EDGE-ON-HUDSON

APPLICATION FOR SITE PLAN & SUBDIVISION APPROVAL

PHASE ONE SUPPLEMENTAL SUBMISSION

Re: Phase 1 Site Plan and Subdivision Application
Edge-On-Hudson Riverfront Development
199 Beekman Avenue, Sleepy Hollow

SP-3.2

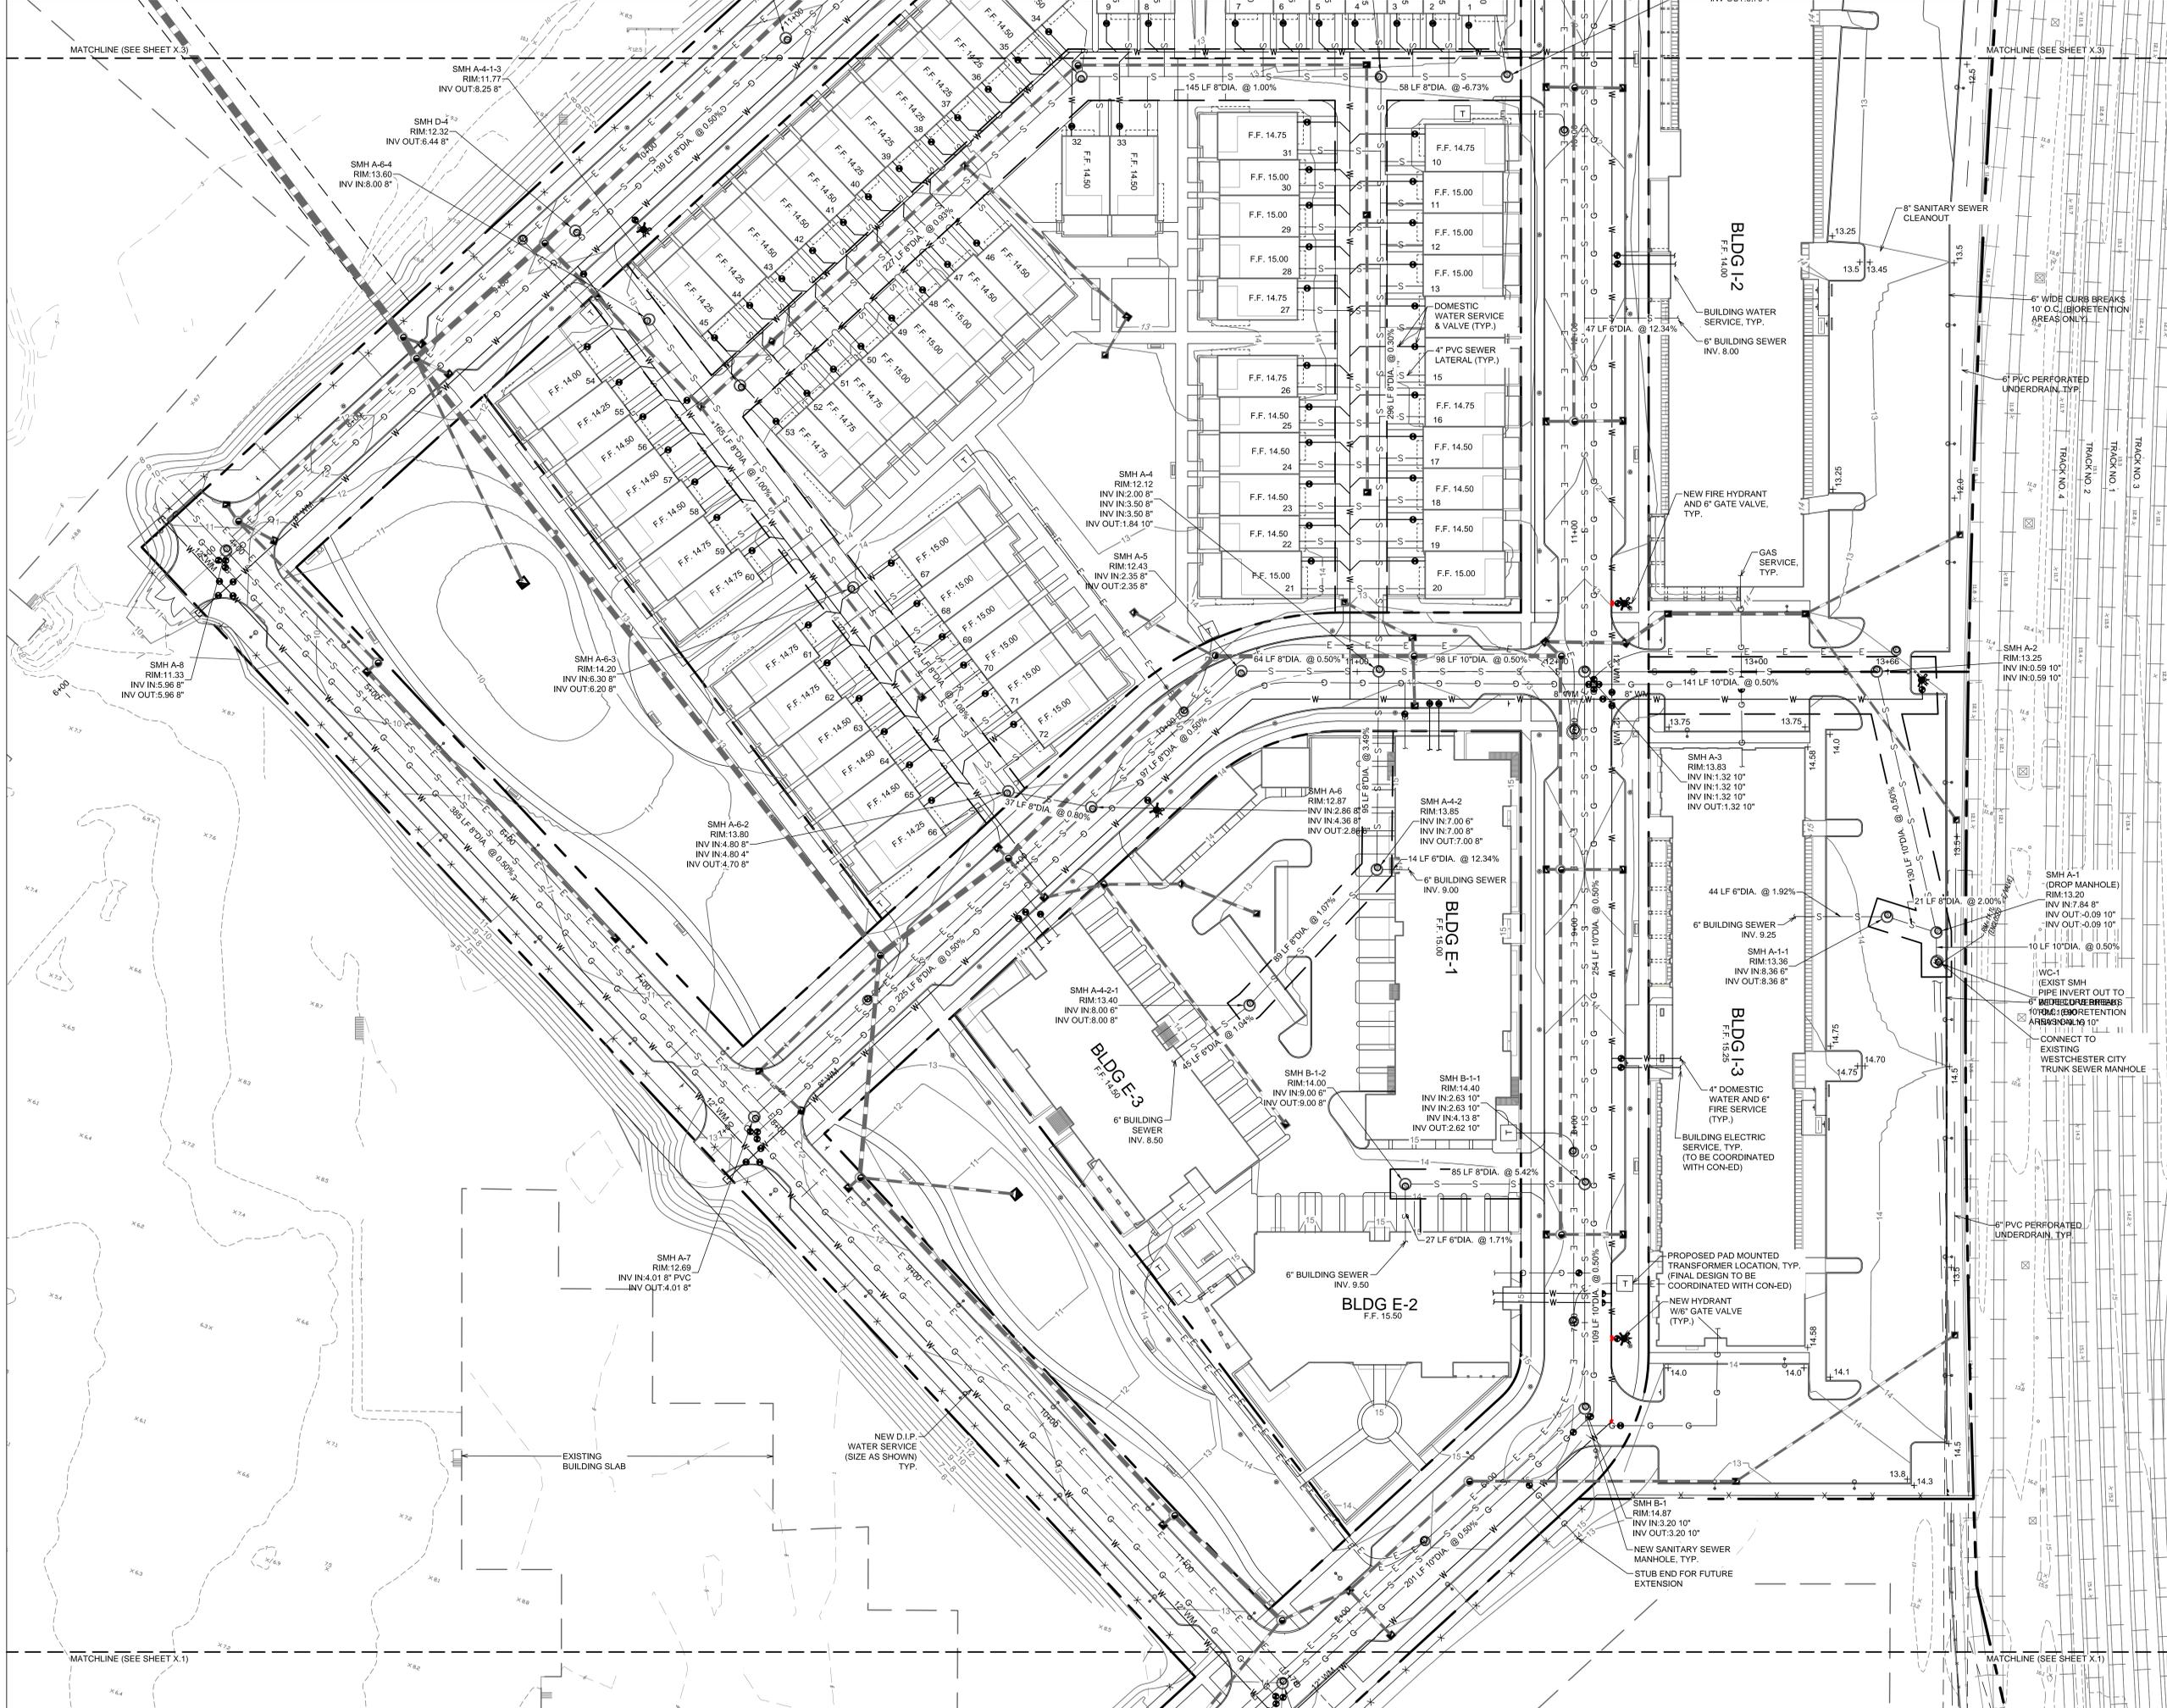
G8. **Comment** *Easements must be provided for water and sewer mains behind town homes.*

Response Comment noted. Proposed easement locations behind townhomes have been added to Sheets SP-3.2 and SP-3.3 for Planning Board review and will be shown on the Preliminary and Final Plats.

DRAWN BY:	CR	CHECKED BY:	MSG
	PROJECT NO.:	780	DATE:	05/07/15
DRAWING NO.:		SP-7.1

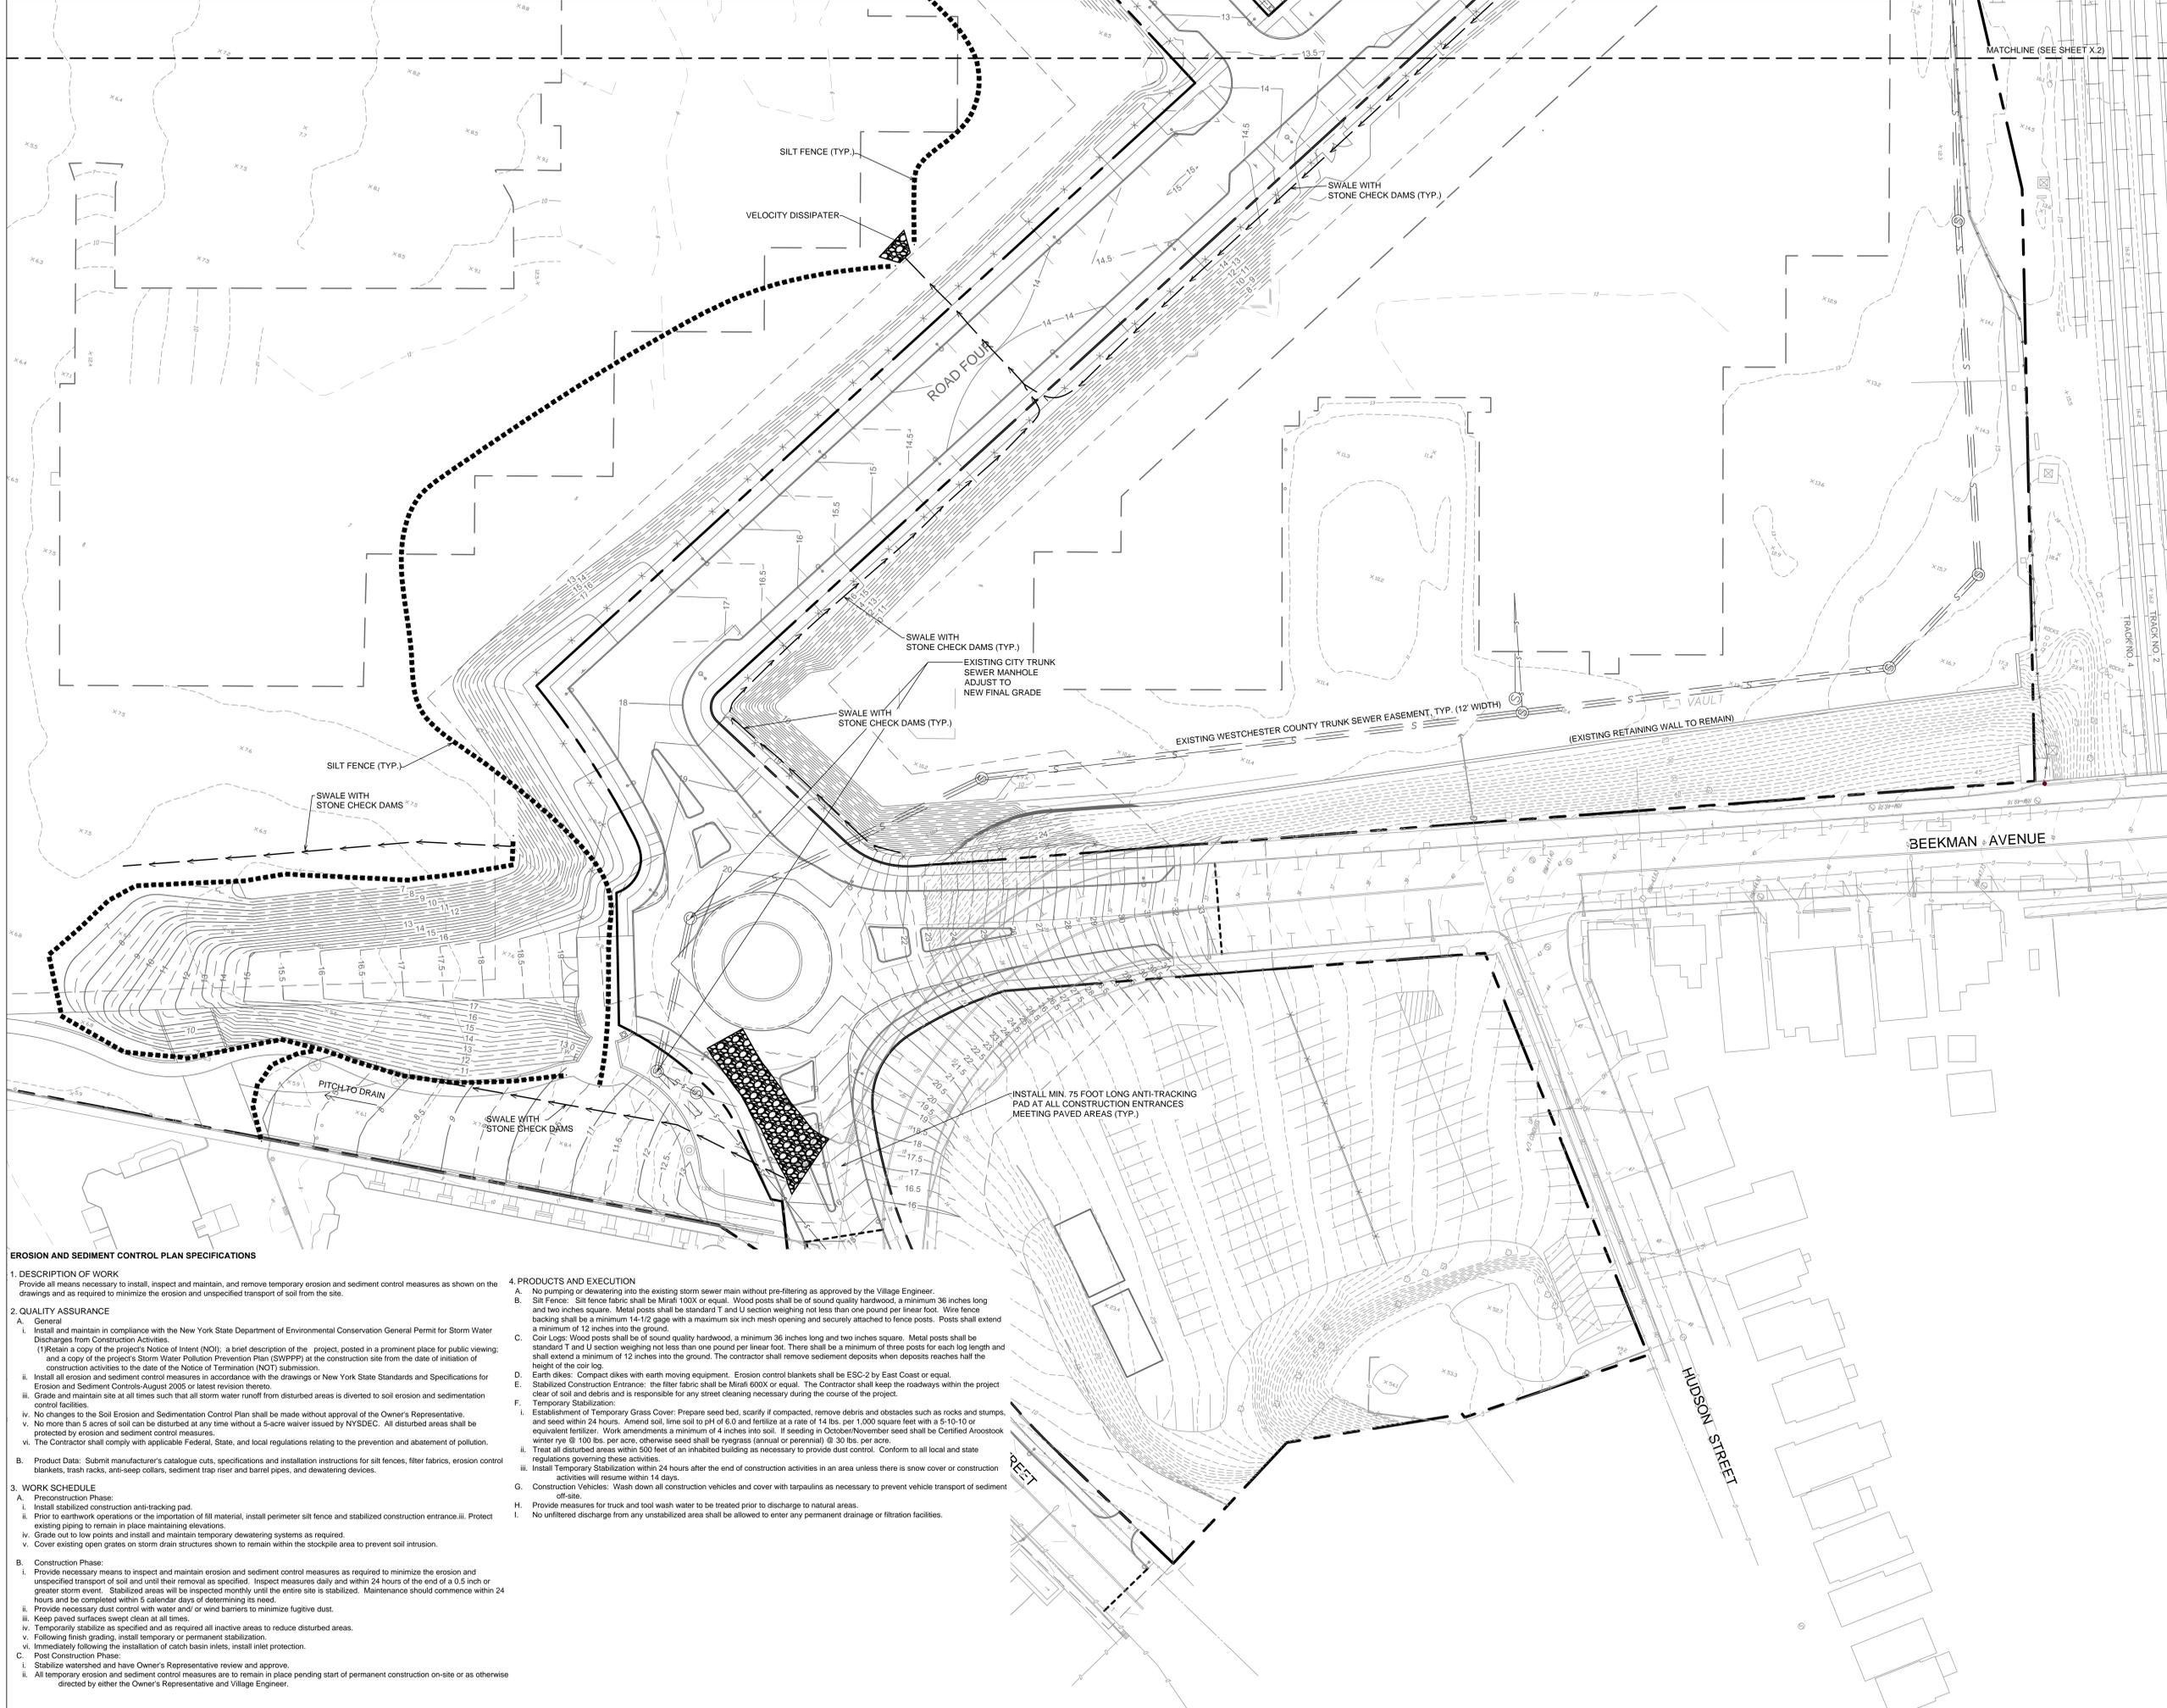
EC1. Comment: *Why does the silt fence not encompass the road fill extending from the temporary overlook area?*

EC2. Comment: *The anti-tracking pad cannot cover the southbound/westbound lane of River Street/Beekman Avenue around the curve.*

Response: The silt fence location shown on Sheet SP-7.1 has been adjusted to encompass the site access fill section extending down to grade from the temporary overlook.

Response: Comment noted. The anti-tracking pad has been shifted approximately 25 feet westward, starting just west of the existing Beekman Avenue/River Street pavement as illustrated on the revised *Erosion & Sediment Control Plan*, Sheet SP-7.1.

SP-8.4

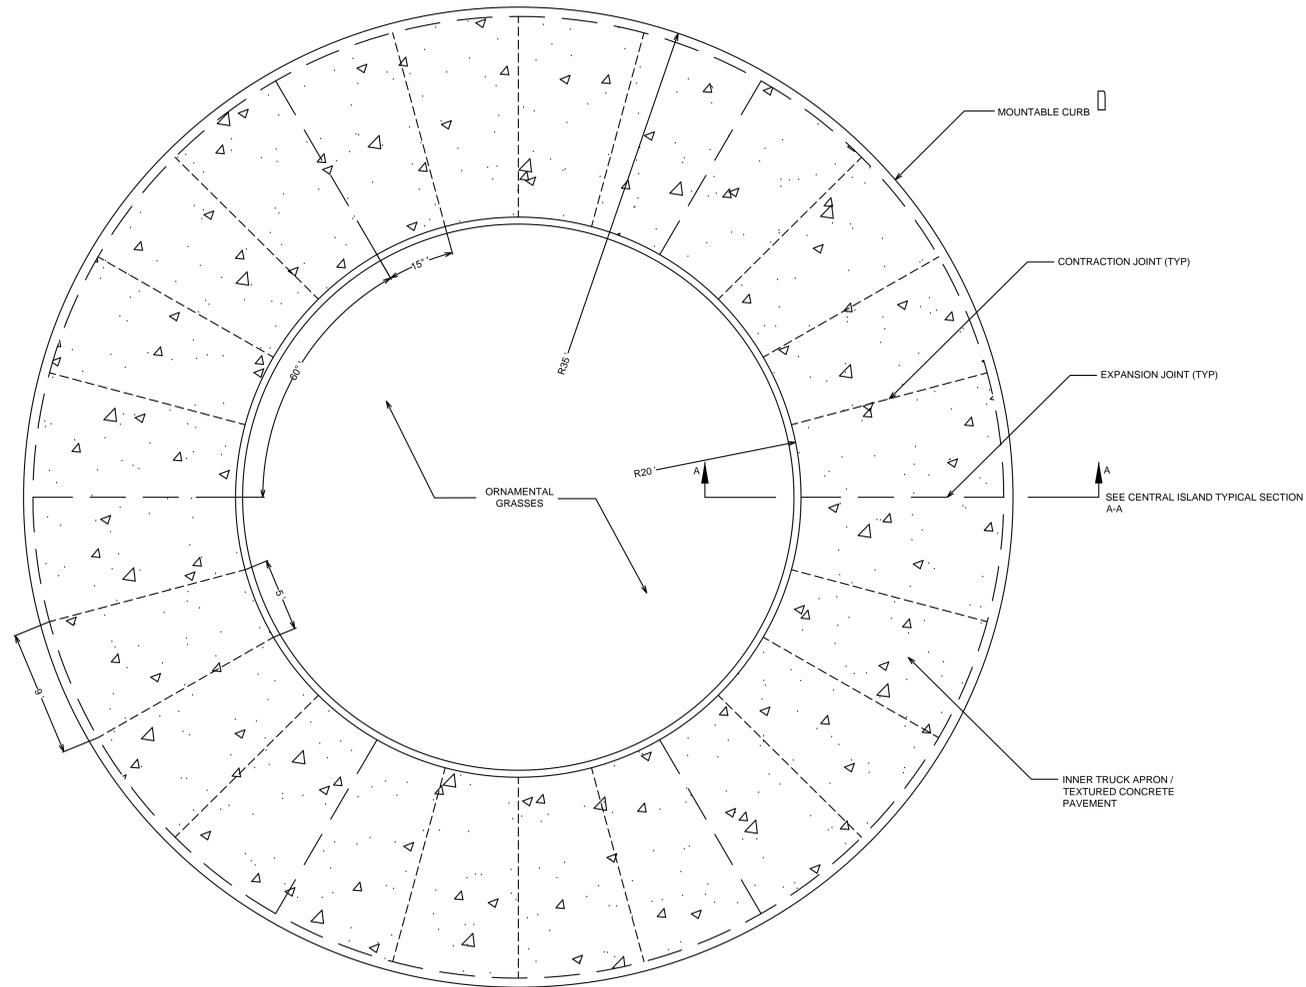
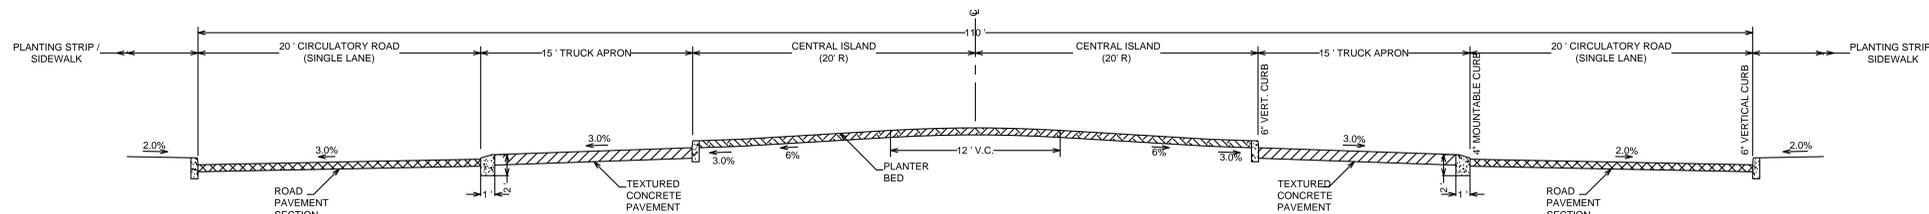
- Response:** Comment noted. Details of the specialty paving at the entrance roundabout, including mountable curbs and textured concrete paving, are shown on Sheet SP-8.4. Groundcover vegetation is currently shown as a placeholder within the interior circle.
